**GOVERNMENT OF INDIA
NORTH EASTERN COUNCIL SECRETARIAT
NONGRIM HILLS, SHILLONG – 793003**

Subject: Forwarding of Inspection Report.

Report of the inspection carried out on 30/04/2018 for the NEC funded project “Construction of Auditorium and Compound Wall of Sainik School Imphal, Manipur”.

Photo showing poor quality of work. Reinforcement of columns exposed.

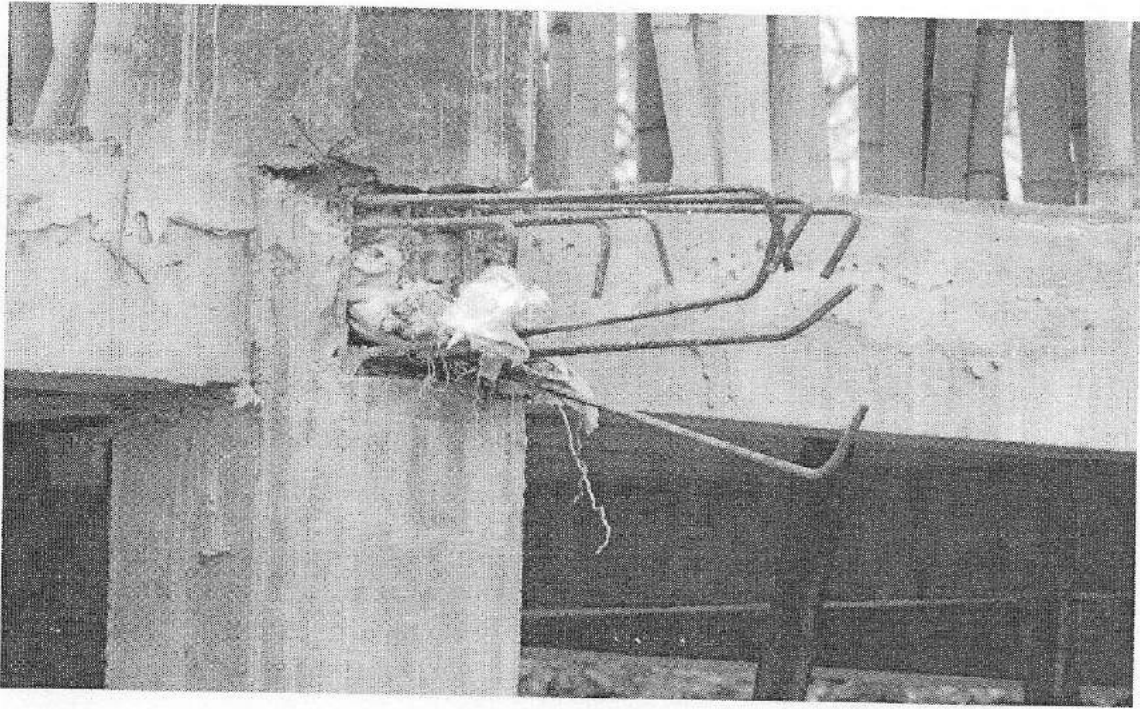
- It was found that in some columns the reinforcement bars are exposed to the atmosphere thus this will cause corrosion in the reinforcement bars and also reduce it strength. Photograph enclosed.

Photo of the extra column constructed to support a deflected beam.

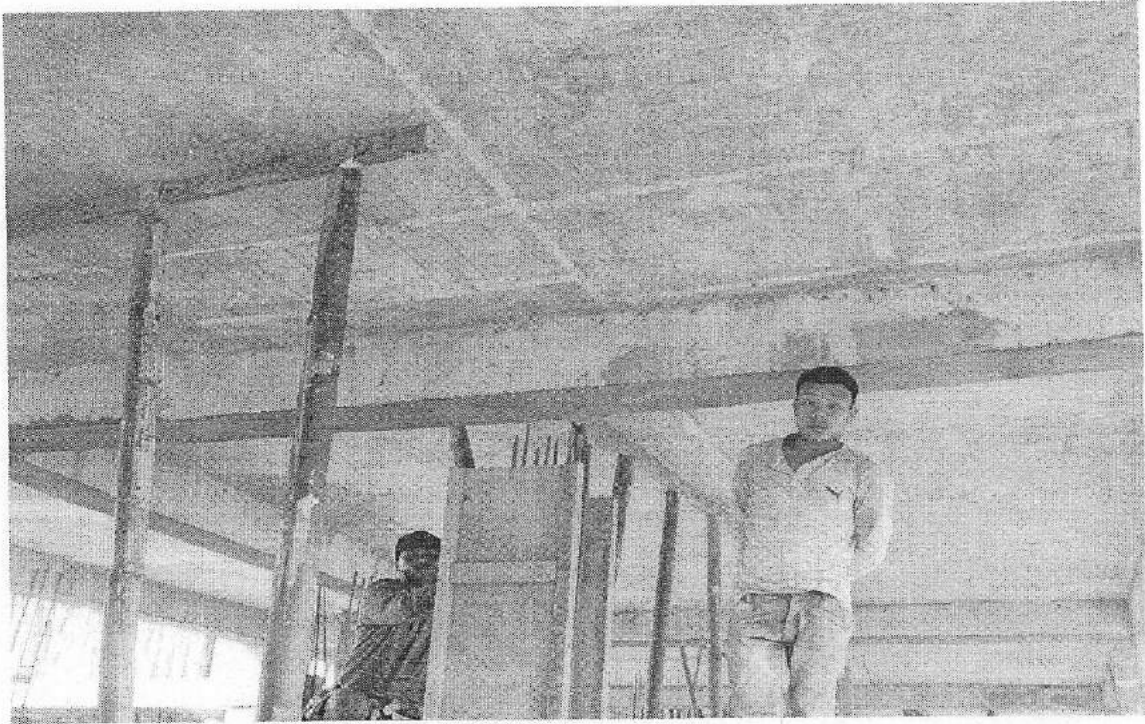
- It could be seen that cracks has occurred in beams of the building and also it was found that many extra columns were constructed at site. The Implementing department informed that these extra columns will help support the beams which have a slight deflection at its mid span.

Photo showing Column size

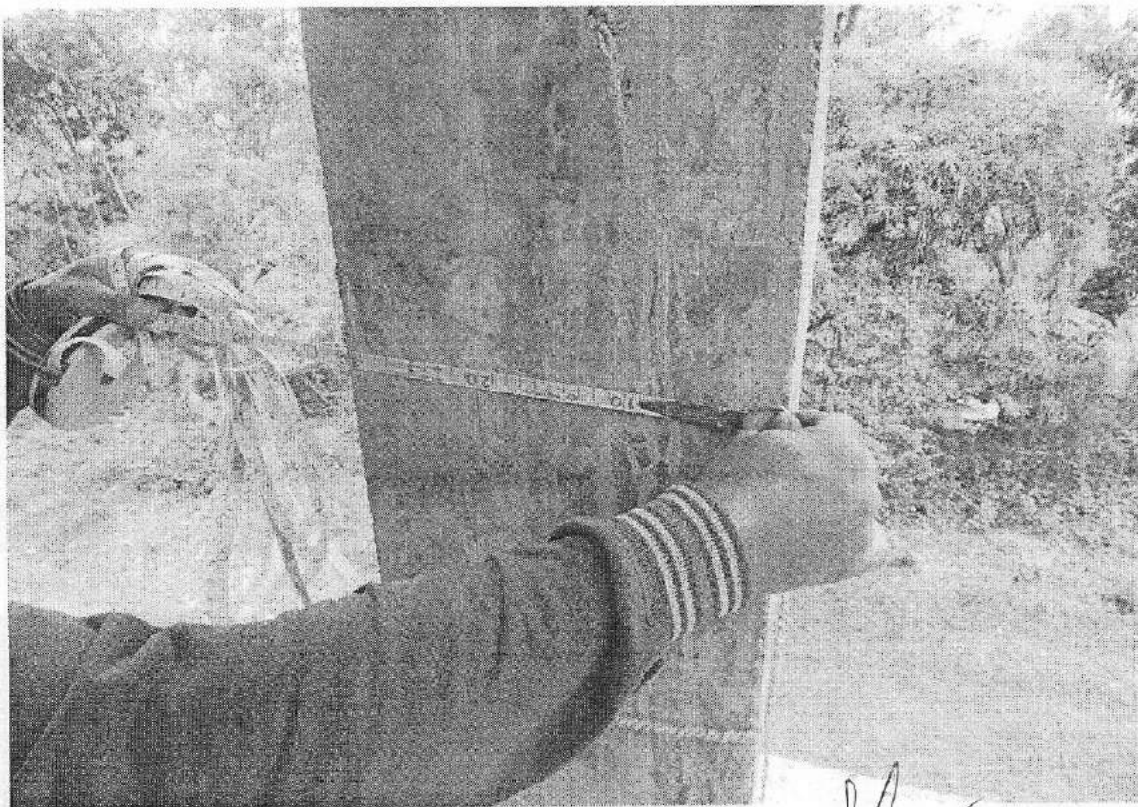
- The Size of columns provided for columns C2 at site was 30cm x 30cm which was not as per specification mentioned in approved DPR. The reinforcement used for columns C2 at site was 4 nos. of 16mm dia bars and 4 nos. of 12mm dia bars which was also not as per specification mentioned in approved DPR. The Implementing department should clarify as to why they reduce the size of both columns and reinforcement bars and also how the columns constructed at site will bear the huge load coming on them when the size of columns and bars were compromised.

- The Size of columns provided for columns C1 at site was 50cm x 35cm which was as per specification but the reinforcement used were 6 nos. of 16 mm dia bar and 4 nos. of 12 mm dia bars which was not as per specification. The implementing department claims that they have used 10 nos. of 16 mm dia bars in foundation and ground floor level. It could be seen in some columns of C1 that reinforcements were bend at the bottom and this could reduce the strength of the reinforcement. The Implementing department should clarify as to how the columns constructed at site will bear the huge tension load coming on them when the sizes of bars were compromised.

Photo showing poor quality of work.

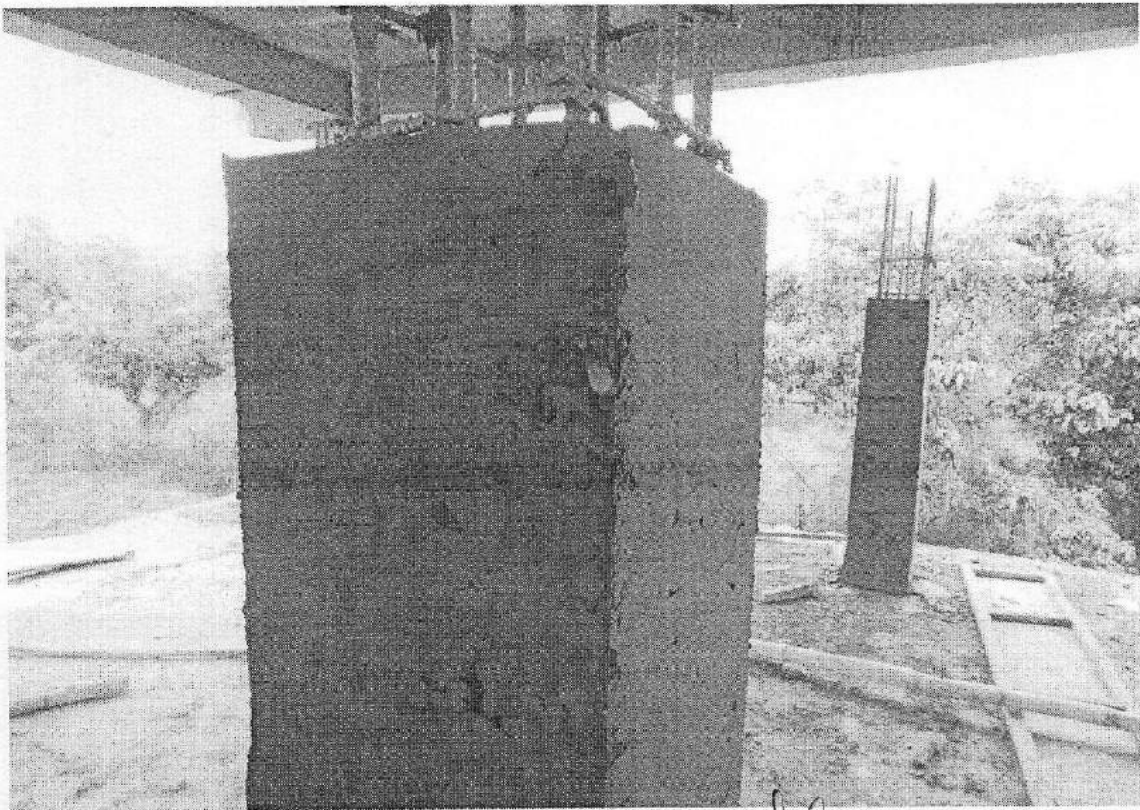
- The quality of work was not upto the mark and the mix used for concreting work was not satisfactory. The Implementing department should conduct a non destructive test on all the columns, beams and slabs of the auditorium building at the project site so as to make sure that the building is safe to withstand a huge amount of load.

- The Implementing department should obtained a certificate from a Structural engineer of a reputed Institute such as NIT or IIT stating that the structural frame (i.e. columns, beams and slab) of the auditorium can bear the huge load coming on them and that the building will not fail structurally.
